FAQ Number 16-00XX0011 FAQ Revision 0
FAQ Title Cable Tray Ignition

Plant:	<u>Harris</u>	Date:	<u>June 2, 2016</u>
Contact:	<u>Harold Stiles</u>	Phone:	<u>(919) 546-4570</u>
	<u>Robert Cavedo</u>	Email:	<u>Harold.Stiles@Duke-Energy.com</u>
	<u>Francisco Joglar</u>		<u>Robert.Cavedo@ExelonCorp.com</u>
	<u>Kyle Christiansen</u>		<u>FJoglar@jensenhughes.com</u>
	<u>Young Jo</u>		<u>Chris1K@Westinghouse.com</u>
			<u>vgjo@southernco.com</u>

This FAQ clarifies the guidance in NUREG/CR-6850 associated with damage and ignition of cables subjected to fire generated conditions in order to provide a more realistic characterization of fire propagation in stacks of cable trays. Specifically, this FAQ establishes guidance for identifying the conditions necessary for cable tray ignition and propagation through an arrangement of cables trays.

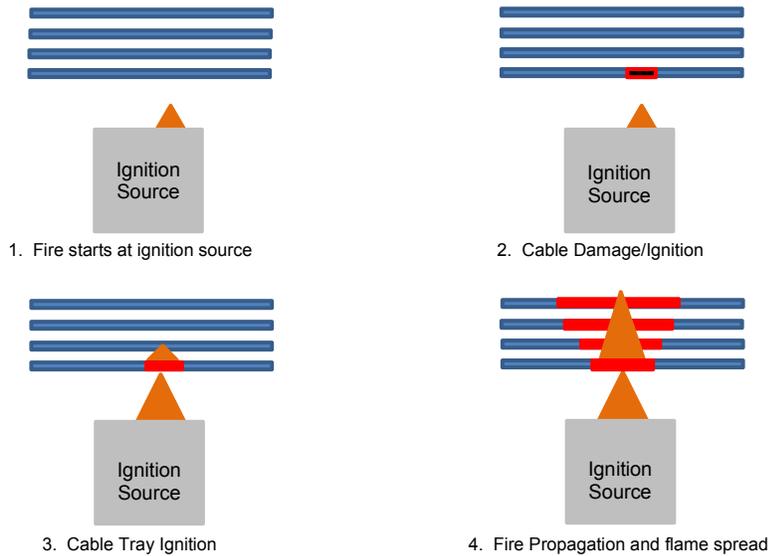
Commented [TG26R25]: Also, cable type could play a role depending on how this guidance wants to develop. If it is to be a one-size-fits-all approach then cable type would not be important as a bounding estimate would be used. Otherwise, we know that different types of cables (TS, TP, qualified/nonqualified, etc.) perform differently, and as such the guidance should follow what we know.

Commented [MB25]: These values contradict available data and literature. These values also indicate the presence of flashover conditions. For instance, available literature and preliminary research data suggests much lower criteria, e.g., the Babrauskas Ignition Handbook suggests piloted ignition values ranging from 276-541 °C. Recent testing by RES tends to support this with piloted ignition values ranging from 285-408 °C. In addition, if this method pertains only to ignition, we should specify and justify whether the criteria represent piloted ignition or auto-ignition.

Commented [TG27]: Is threshold the same as criteria? This should be made consistent or clear.

Commented [MB28]: How is this different from FLASH-CAT? How does the proposed method distinguish between vertical and lateral spread?

Commented [MB29]: This method seems to beg the question of how much time or fire is assumed between the time the first cable ignites, grows large enough to spread, and then ignites the next cable or tray above. For instance, if using a centerline plume temperature calc. an analyst would know how the temperature changes with elevation but still wouldn't know much about an ignited surface area of cable without making some other assumptions.
